Access Compliance Report Public Rights-of-Way (Pedestrian Signals)

Intersection ID: N/A	Main Street:	Cross Street: N/A	Location: N/A
ADA ID: CDD85E3E803E	Signal Type: One Push Button-Non APS	Overall Compliance: No	Severity Score: BTN 1: N/A BTN 2: N/A No BTN: N/A
Codes/Mitigation Info/Possible Solution		Field Measurements/Component Compliance

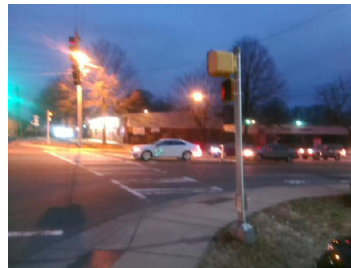
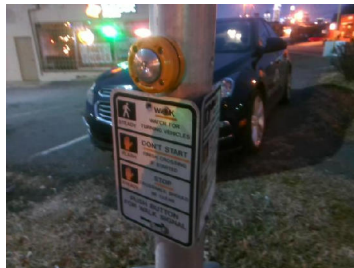
PROW/ADA: R404.3, R404.2, R406.2, R404.7.3

Compliance	Description	Data	Compliance	Description	Data
	Button Count	Button1	N/A	Distant to Additional Button (in)	N/A
	Additional Button Present?	No		Additional Button ID	N/A
N/A	Signal Buttons Required?	N/A	N/A	Additional Ped Posts Required	N/A
	How Many Ped Street Xings?	2		Located In An Island/Median?	No
N/A	B 1 Sign Present?	Yes	N/A	B 2 Sign Present?	N/A
Yes	B 1 Sign Purpose?	Yes	N/A	B 2 Sign Purpose?	N/A
Yes	B 1 Sign Lettering & Contrast?	Yes	N/A	B 2 Sign Lettering & Contrast?	N/A
Yes	B 1 Parallel To XWalk?	Yes	N/A	B 2 Parallel To XWalk?	N/A
No	B 1 PAR to Button?	No	N/A	B 2 PAR to Button?	N/A
No	B 1 PAR to XWalk?	No	N/A	B 2 PAR to XWalk?	N/A
Yes	B 1 Clear Floor Space?	Yes	N/A	B 2 Clear Floor Space?	N/A
N/A	B 1 FWD Approach?	Yes	N/A	B 2 FWD Approach?	N/A
N/A	B 1 FWD Approach Constrained?	No	N/A	B 2 FWD Approach Constrained?	N/A
No	B 1 FWD Approach Reach (in)	22.0	N/A	B 2 FWD Approach Reach (in)	N/A

N/A	B 1 FWD Approach Width (in)	N/A	N/A	B 2 FWD Approach Width (in)	N/A
N/A	B 1 FWD Approach Obstruction?	Yes	N/A	B 2 FWD Approach Obstruction?	N/A
N/A	B 1 FWD Approach Obstruction Dist (in)	17.0	N/A	B 2 FWD Approach ObstructionDist (in)	N/A
N/A	B 1 PARA Approach?	Yes	N/A	B 2 PARA Approach?	N/A
N/A	B 1 PARA Approach Constrained?	No	N/A	B 2 PARA Approach Constrained?	N/A
No	B 1 PARA Approach Reach (in)	12.0	N/A	B 2 PARA Approach Reach (in)	N/A
N/A	B 1 PARA Approach Width (in)	N/A	N/A	B 2 PARA Approach Width (in)	N/A
N/A	B 1 PARA Approach Obstruction?	Yes	N/A	B 2 PARA Approach Obstruction?	N/A
N/A	B 1 PARA Approach Obstruction Dist (in)	12.0	N/A	B 2 PARA Approach ObstructionDist (in)	N/A
Yes	B 1 Clear Floor Space Slope (%)	5.5	N/A	B 2 Clear Floor Space Slope (%)	N/A
No	B 1 Clear Floor Space XSlope (%)	2.1	N/A	B 2 Clear Floor Space XSlope (%)	N/A
N/A	B 1 PAR Slope (%)	6.3	N/A	B 2 PAR Slope (%)	N/A
Yes	B 1 Height (in)	32.0	N/A	B 2 Height (in)	N/A

Possible Solutions: Provide PAR As Indicated. Provide Push Button Extension. Remove and Replace Clear Space.
